Access Compliance Report Public Rights-of-Way (Pedestrian Signals)

Main Street: ORTEGA_HWY Cross Street: ORTEGA_HWY Location: SE

ADA ID: SGRK211118130422 Signal Type: One Push Button-Non APS Overall Compliance: No Severity Scores: BTN 1: 35 BTN 2: N/A No BTN: N/A

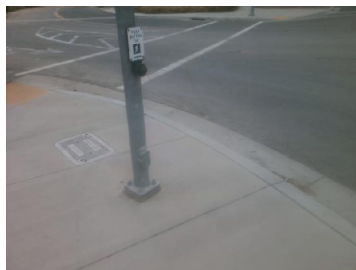
OC Std/PROW: MUTCD 4e.08, R404.2

Possible Solutions: Replace Signal Push Button With APS Button. Remove & Relocate Sign.
